TRANSPORT NOTE
RESPONSE TO LCC HIGHWAY CONSULTATION
ERECTION OF A PIPE MANUFACTURING FACILITY WITH ASSOCIATED STORAGE
FP MCCANN LTD, BRASCOTE LANE, CADEBY,
NUNEATON, LEICESTERSHIRE, CV13 0BB
(ADL/AM/5321/TN/03B)

- 1.1 ADL Traffic and Highways Engineering Ltd (ADL) have prepared this Transport Note (TN), on behalf of the Applicant 'FP McCann Ltd', in response to Leicestershire County Council (LCC) consultation response dated 12th May 2025 regarding the planning application (ref. 25/00306/FUL) for the erection of a pipe manufacturing facility with associated storage at Brascote Lane, Cadeby, Nuneaton.

Figure 6A Proposed Car Park Layout

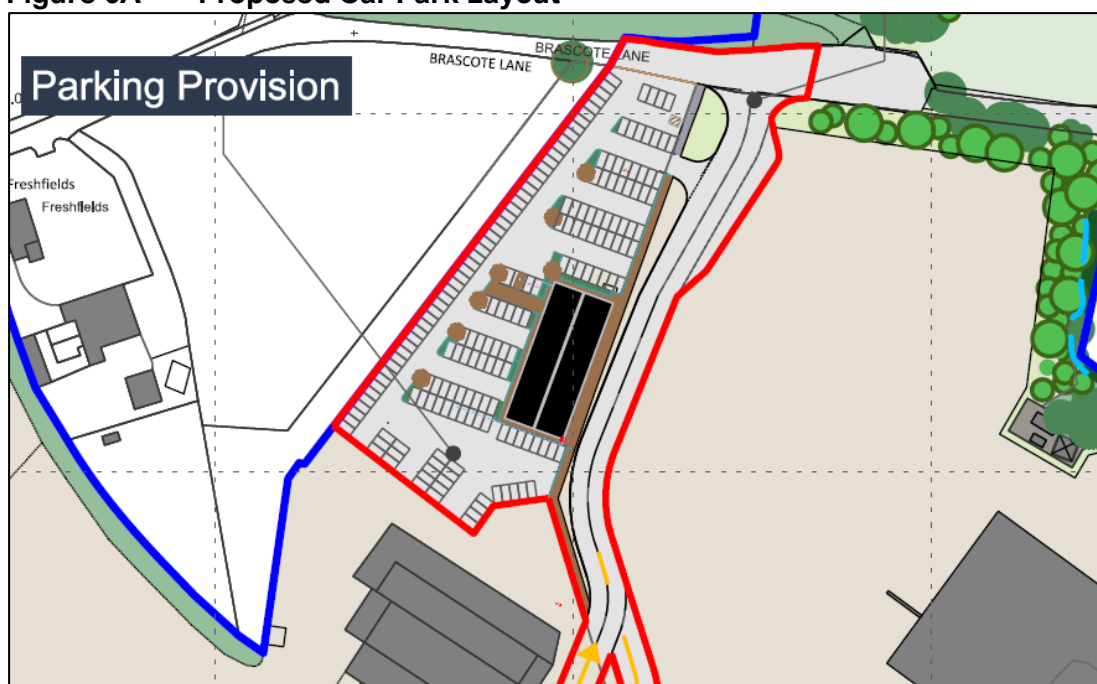
“Based on Table 29(a) of the LHDG, an out of any town development with B2 use would require a minimum of 1 parking space per 55sqm. For a development with an internal floorspace of 5,490sqm 100 car parking spaces would therefore be required. Given the level of parking is a fifth of the minimum parking spaces required as per the LHDG, and provision would reduce the level of parking available for the other permitted uses on-site as it is within the same car park, the LHA advise the Applicant should seek to provide further information and a further parking area. Whilst it is acknowledged only 20 employees are anticipated for each shift, it is unclear where staff for the next shift would park at shift changeover times for example. This could also be a problem for the wider site if parking provision is reduced.”

- 6.4 The proposal is to allocate 20 spaces within the existing car park to the new facility. The proposed car park layout is shown in Figure 6A below.

- 6.5 There are a total of 183 car parking spaces shown within the car park as above. This car park layout reconfiguration will be implemented in association with the construction of new office approved under application ref. 23/00926/FUL (to replace all office and welfare facilities at the site).
- 6.6 As a result of the current office construction, some parts of the existing car park (shown orange) are temporarily closed / unavailable and staff car parking has been relocated to other hardstanding areas within the site (shown green) as per the Google Aerial imagery shown below.
